P24-14
South Harmony Street Additions

Property Owner: Louis and Julie Schubert
 Applicant: Louis and Julie Schubert
 Location: 248 South Harmony Street
 Zoning: R-2 (Medium Density Residential)
 Request: Certificate of Appropriateness approval for additions in the TC-OV District

COMMUNITY DEVELOPMENT DEPARTMENT STAFF RECOMMENDATION

PRELIMINARY PLOT PLAN PREPARED FOR
 OLD WORLD CUSTOM HOMES
 SITUATED IN THE CITY OF MEDINA
 COUNTY OF MEDINA, STATE OF OHIO

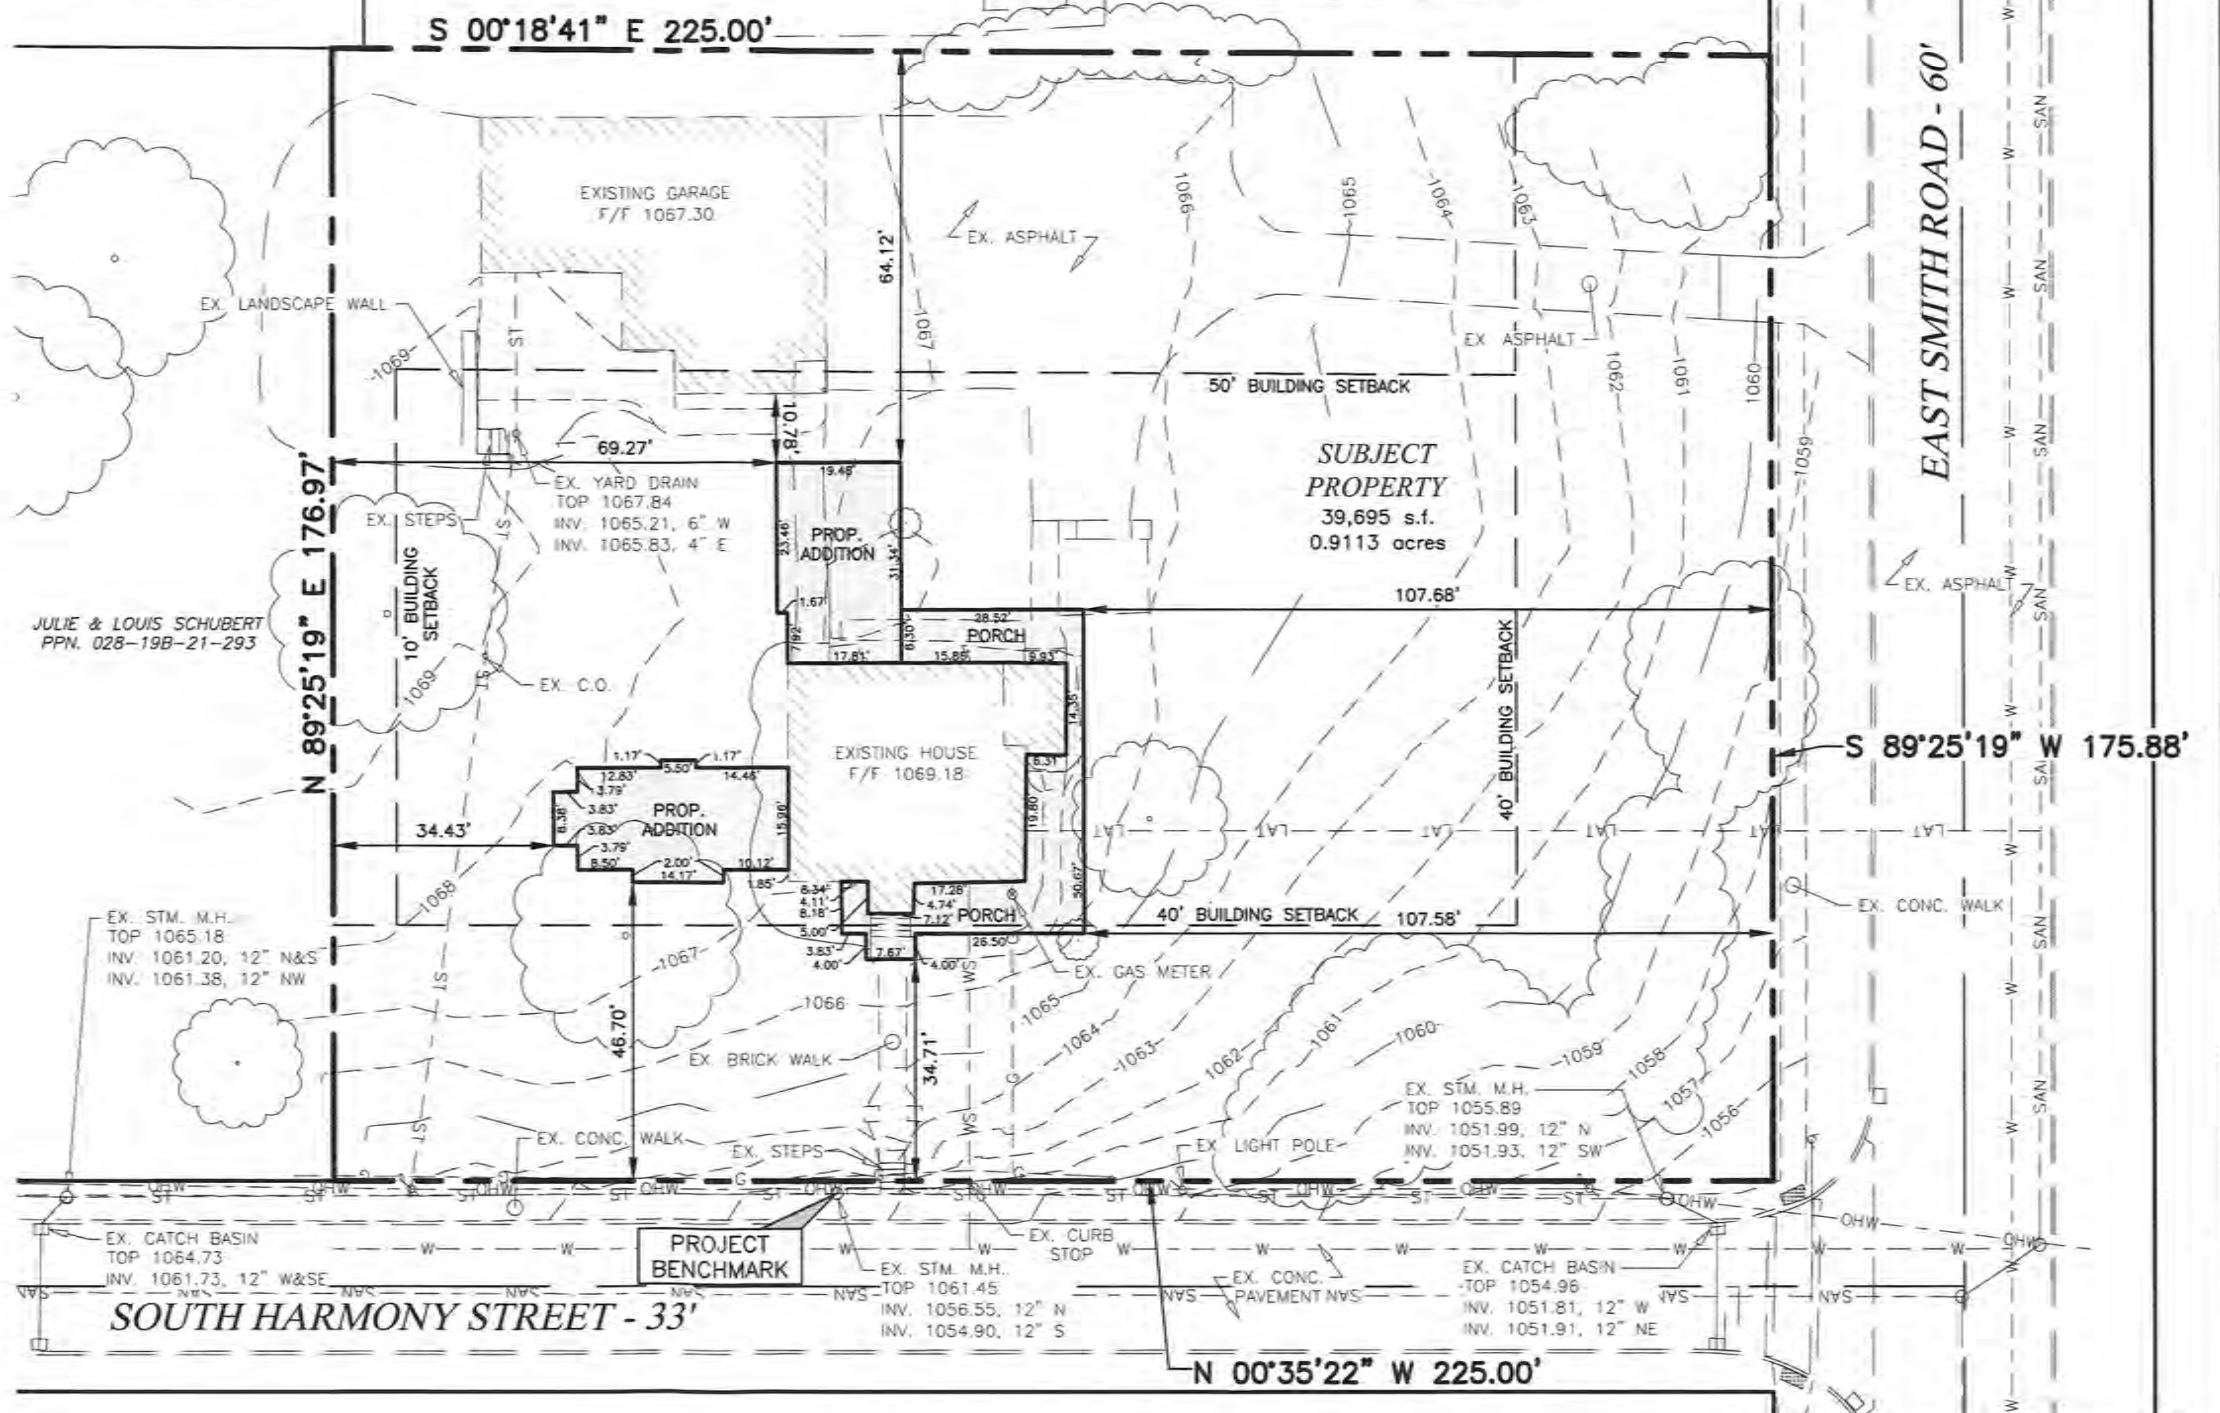
The property is located on a corner lot, which effectively has two front yards adjacent to South Harmony Street and East Smith Road. The required setback from each right-of-way is 40 ft., per Section 1123.05. The existing principal structure is located 41.15 ft. from the South Harmony Street right-of-way and 110 ft. from the East Smith Road right-of-way.

The two proposed additions meet the required setbacks from the rights-of-way. However, the covered porch is located 34.71 ft. from the South Harmony Street right-of-way. The applicant has filed a variance to Section 1123.05 to allow the covered porch to project into the required front setback.

Staff recommends approval of application P24-12, as submitted with the condition that the project shall comply with Planning and Zoning Code Section 1123.05 regarding front yard setbacks or a variance shall be approved by the Board of Zoning Appeals.

FRONT & REAR ELEVATION

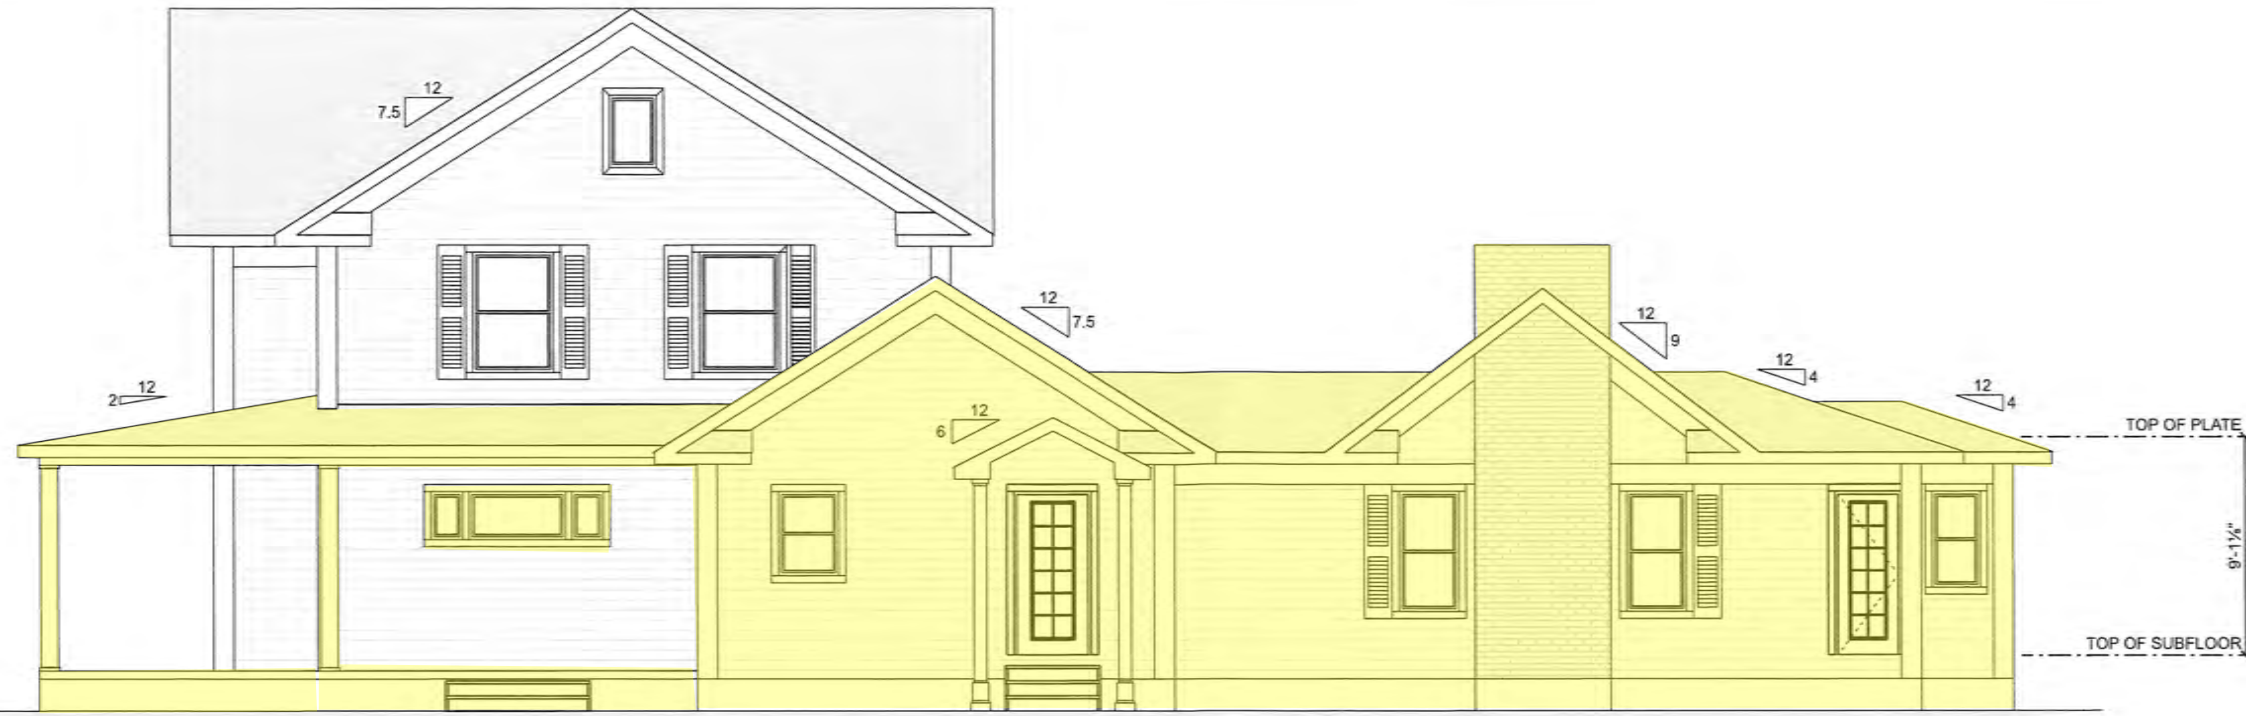
The proposed single story additions on the side and rear of the home incorporate vinyl siding, asphalt shingles, and multiple windows and rooflines. The sides of the home facing streets include a wrap-around porch. The side of the home facing East Smith Road also includes the replacement of two smaller second story windows with a single larger window.

TCOV.6(c) above indicates that the front of the buildings should not exceed fifty (50) feet in horizontal length. The fronts of the building are 70 ft. facing South Harmony Street and 79 ft. facing East Smith Road. The site is 225 ft. wide on South Harmony Street and 177 ft. wide on East Smith Road, which is far wider than most residential lots in the area. As the requirement indicates “should” rather than “shall”, the Planning Commission may or may not find the regulation applicable to the proposed project.

The applicant will need to indicate the colors of the proposed siding and roofing, which are assumed to match the home.

- The color of the proposed siding and roofing
Black dimensional shingles. White Hardie lap siding
- Color and material of proposed windows
Pella lifestyle series- white aluminum clad exteriors
- Type of existing siding
Aluminum lap siding
